AR LIT RNAV (GPS) RWY 36 ADMT 1

4-12-2022 PRB Results: Returned Pre PRB

Subject: Approval Request: BILL AND HILARY CLINTON NATIONAL/ADAMS
FIELD (LIT), LITTLE ROCK, AR (KLIT) RNAV (GPS) RWY 36

RNAV (GPS) RWY 36
BILL AND HILLARY CLINTON NTL/ADAMS FLD (LIT)

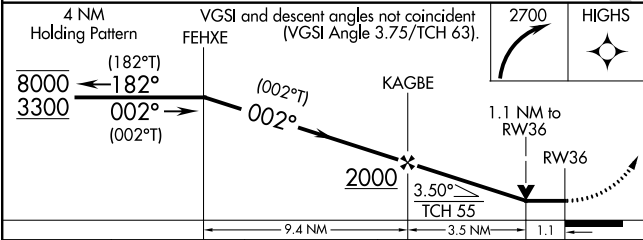
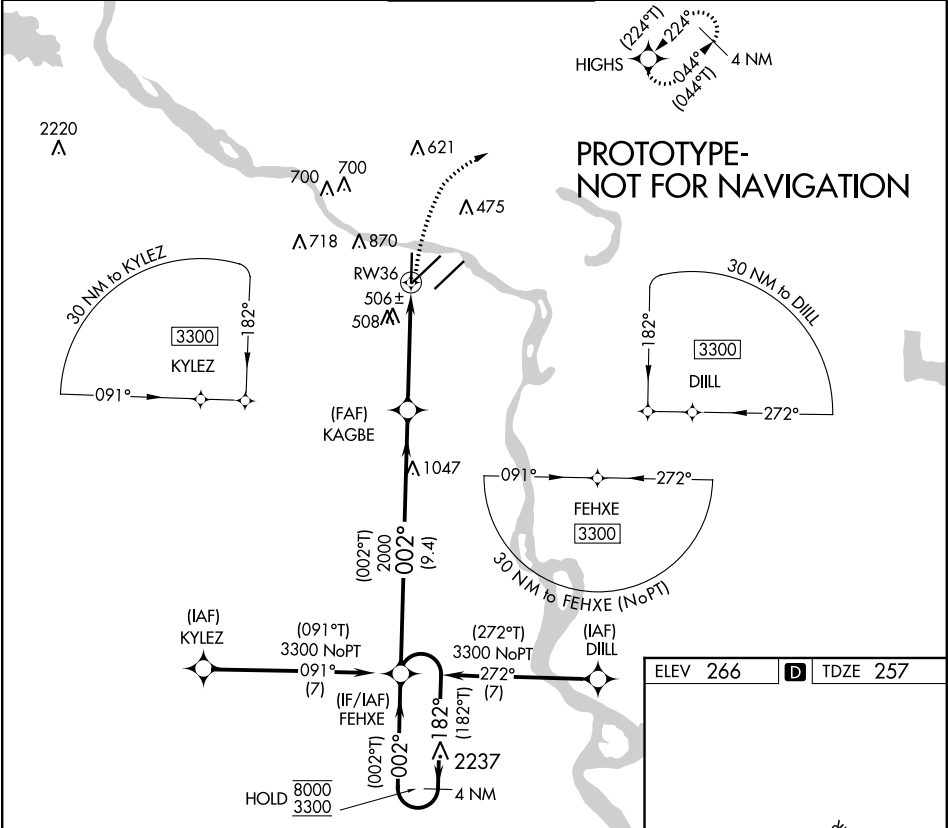
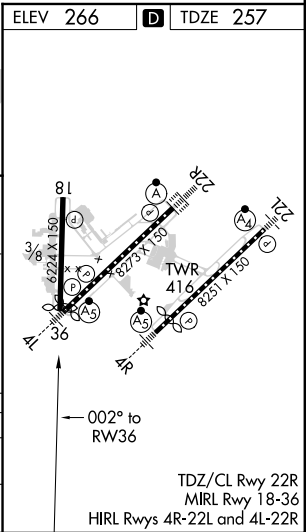
The procedure as been rebuilt to a VDA/TCH of 3.50/55 to mitigate the difference in the VGSI angle and retain CAT D minimums. FPT requests to keep CAT D minimums due to military aircraft that use the airport. Currently, the VDA/TCH is not published but updated flight check does not require this limitation. If allowed we will ensure a VGSI NON-COINCIDENT NOTE be published to identify the differences.

The FPT has confirmed the VGSI has previously been lowered from 4.0 but due to the visual slope penetrations it cannot be lowered below 3.75. All efforts were made to match the 3.75 VDA however, this would eliminate CAT D minimums. The FPT requests that we do not remove CAT D minimums because they are used for military flights at the airport. Therefore, the procedure was built with a 3.5 VDA - the highest usable VDA for CAT D minimums IAW 8260.3E Table 2-6-1.

Request approval to publish a 3.50 VDA.

RNAV (GPS) RWY 36

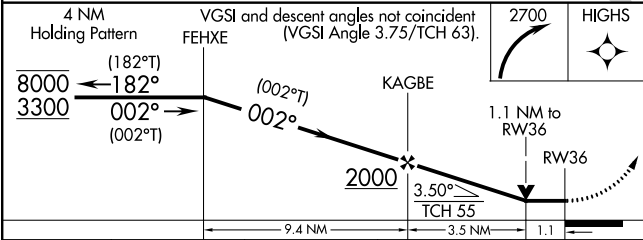
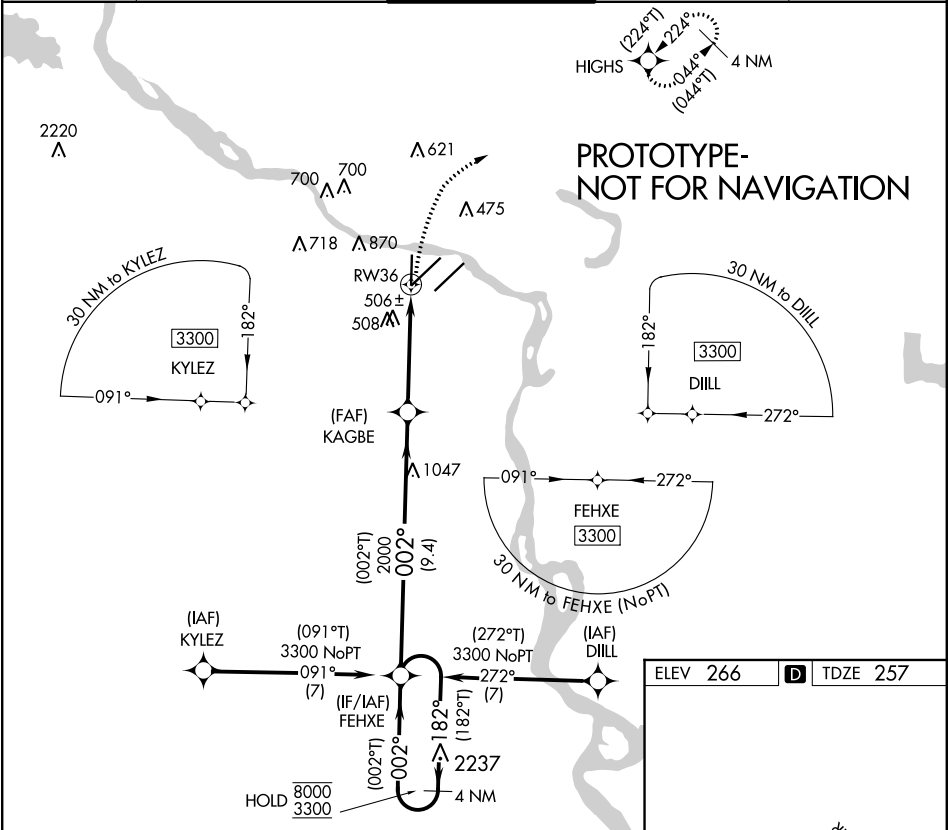
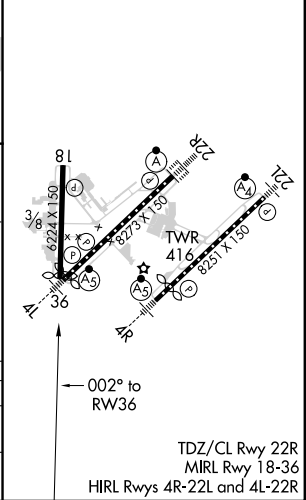
The procedure as been rebuilt to a VDA/TCH of 3.50/55 to mitigate the difference in the VGSI angle and retain CAT D minimums. FPT requests to keep CAT D minimums due to military aircraft that use the airport. Currently, the VDA/TCH is not published but updated flight check does not require this limitation. If allowed we will ensure a VGSI NON-COINCIDENT NOTE be published to identify the differences.

The FPT has confirmed the VGSI has previously been lowered from 4.0 but due to the visual slope penetrations it cannot be lowered below 3.75. All efforts were made to match the 3.75 VDA however, this would eliminate CAT D minimums. The FPT requests that we do not remove CAT D minimums because they are used for military flights at the airport. Therefore, the procedure was built with a 3.5 VDA - the highest usable VDA for CAT D minimums IAW 8260.3E Table 2-6-1.

Request approval to publish a 3.50 VDA.
